Arlington Conservation Commission

Date: Thursday, February 15, 2024

Agenda

DEP #091-0356: Notice of Intent: Thorndike Place (continued from 2/1/2024)

Figure 1 – Site Plan Hydrology (Groundwater Levels -Blue, Wetlands Elevations - Green)

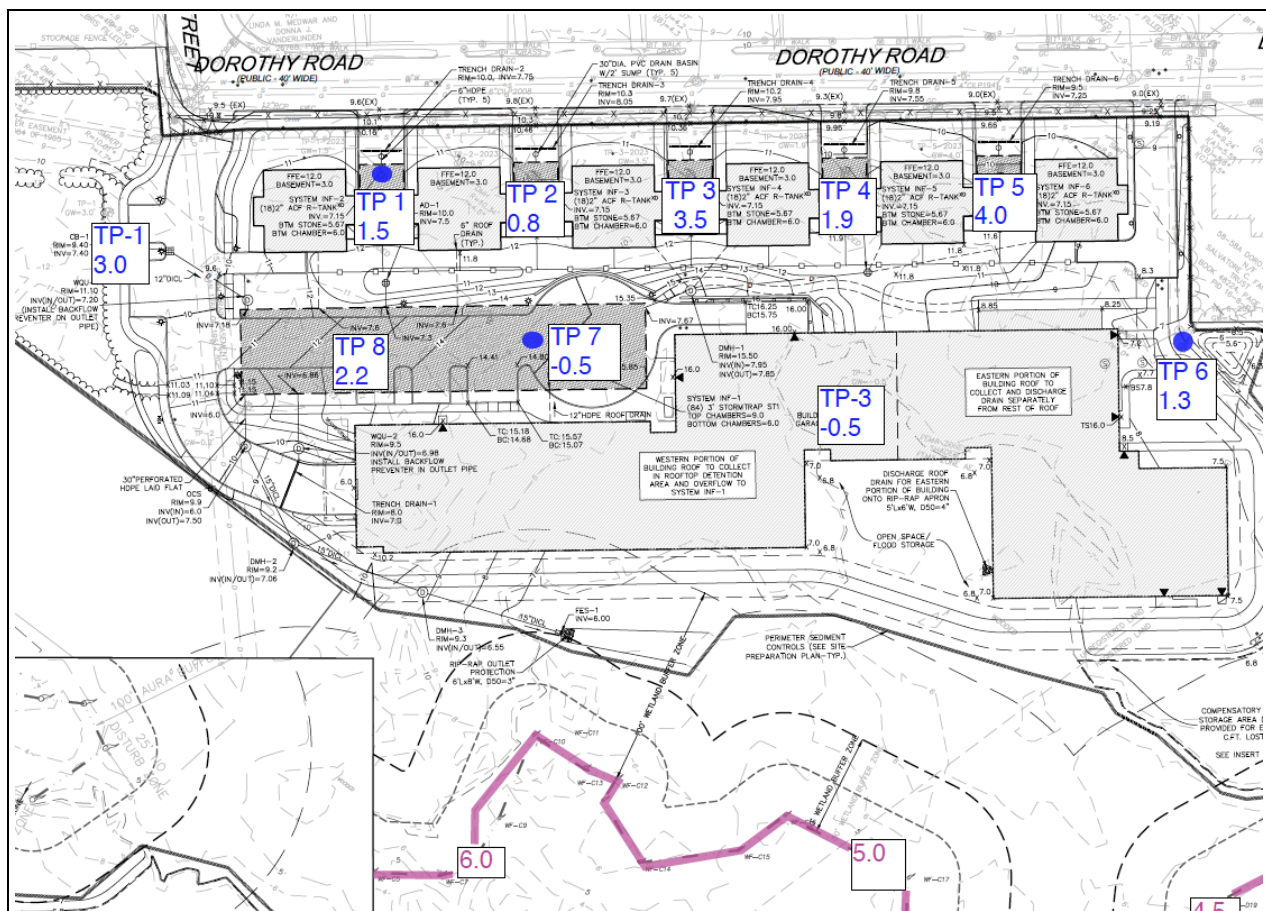
As was stated at the last hearing the Applicant proposes to rely upon mottling (redox) markings at Test Pit 5 which is located approximately 150 feet outside of the proposed infiltration system 1 and to ignore/discount the mottling (redox) features noted at Test Pit 7 (that is located within the footprint of the proposed infiltration system #1) – see figure 1.

SHEET G-101

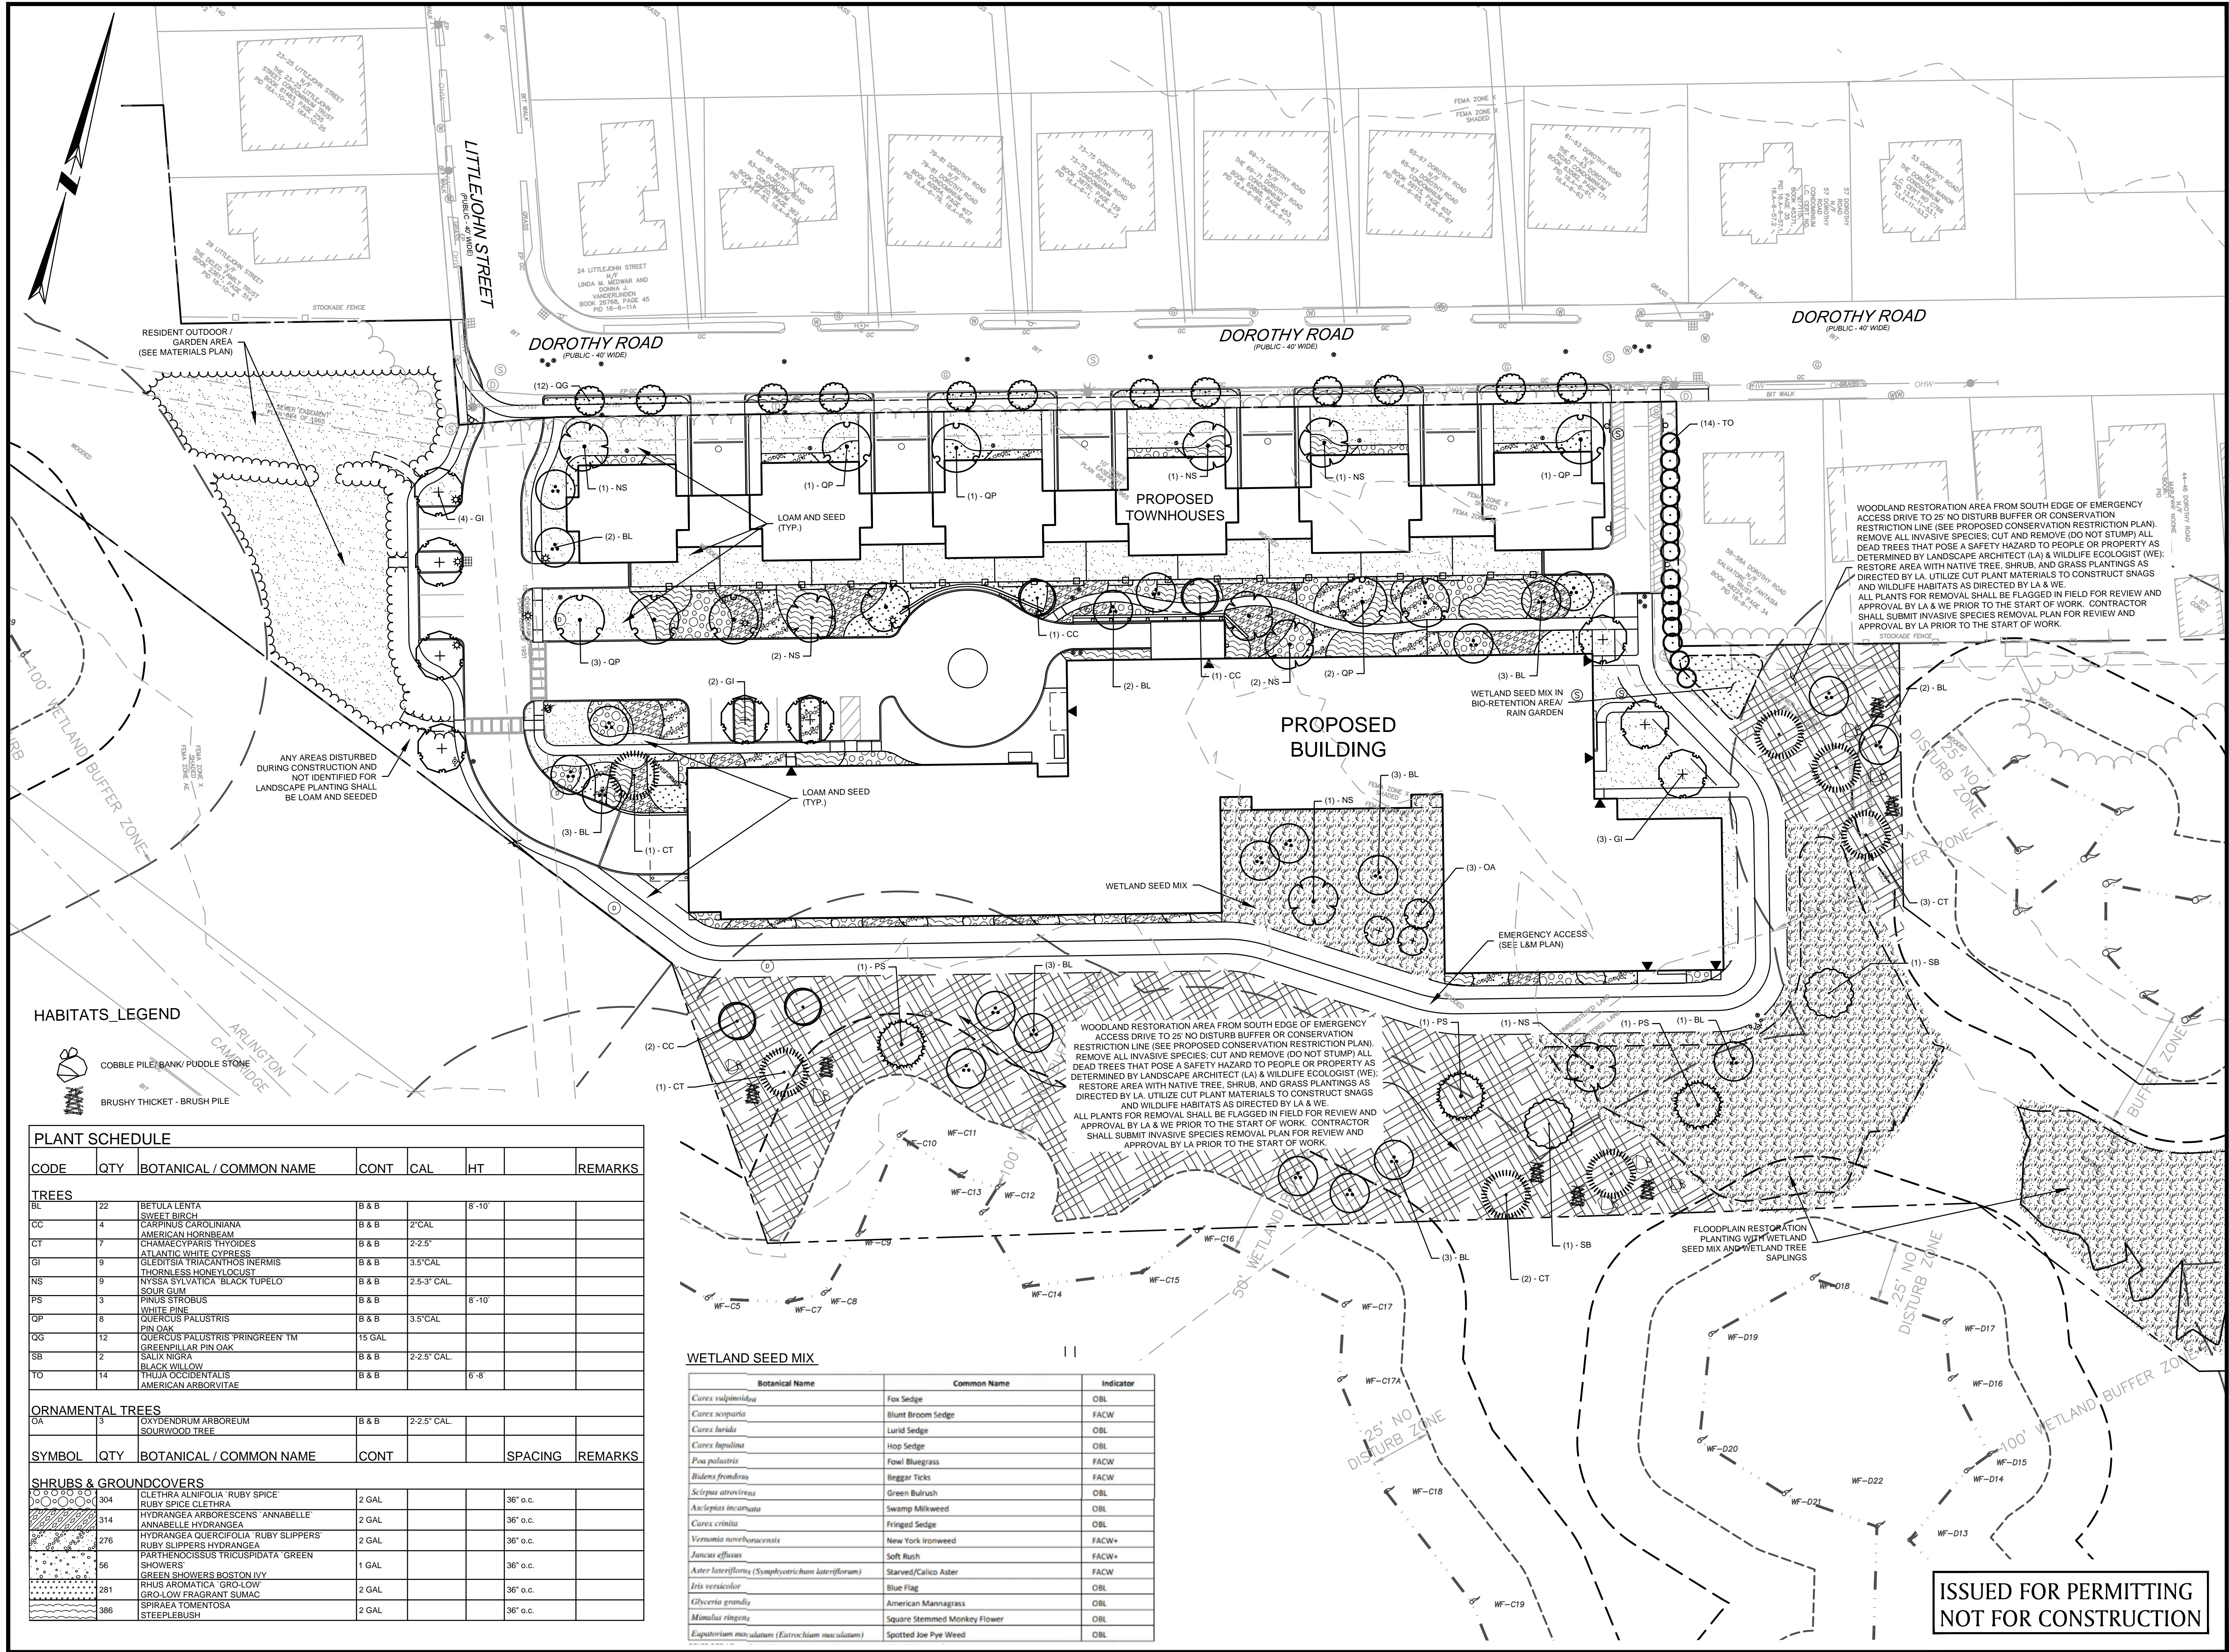
SWCA Comment 6: Sheet G-101, Planting Notes, Note 11. The site plans indicate that the plant species indicated on the plant list are recommendations only and that final selection of the species shall occur at the time of plant purchase, depending on availability and that the size and quantity shall not change without approval of the Applicant's landscape architect.

SWCA Comment 7: Sheet G-101, Comprehensive Permit Notes, Comment I.5. This comment notes that dumping of woody vegetation, brush, and other debris in a resource area or its associated buffer zone is prohibited.

SWCA Comment 8: Sheet G-101, Comprehensive Permit Notes, Comment I.25. The site plans note that the survival rate of planted species shall be 80% at the end of the third year and that a corrective action plan must be submitted if the survival rate is less than 80% at the end of the third year.

BSC Response 6: BSC has made the recommended revision to the Sheet G-101 Planting Notes, Note 11. We recommend that the Order of Conditions allow administrative approval of such availability-based changes by the Conservation Commission or its authorized representative to prevent undue construction delays in making such substitutions if necessary.

BSC Response 7: Sheet G-101, Comprehensive Permit Notes, Comment 1.5 is a Condition of the Comprehensive Permit, and the wording is copied directly from that Condition. The intent of the Condition is to prohibit the dumping of materials removed during construction in the wetlands or buffer zone. In accordance with BSC Response 4 above, the Restoration Plan will be updated with detailed natural coarse woody debris and stone wildlife habitat features using materials originating from the site, but material removed from the site during construction will not be disposed of within resource areas or associated buffer zones in accordance with the Comprehensive Permit condition.

BSC Response 8: Sheet G-101, Comprehensive Permit Notes, Comment I.25 is a condition of the Comprehensive Permit, and the wording is copied directly from that Condition. The Comprehensive Permit Condition was prepared upon the recommended conditions submitted to the Zoning Board by the Conservation Commission by letter dated October 14, 2021.
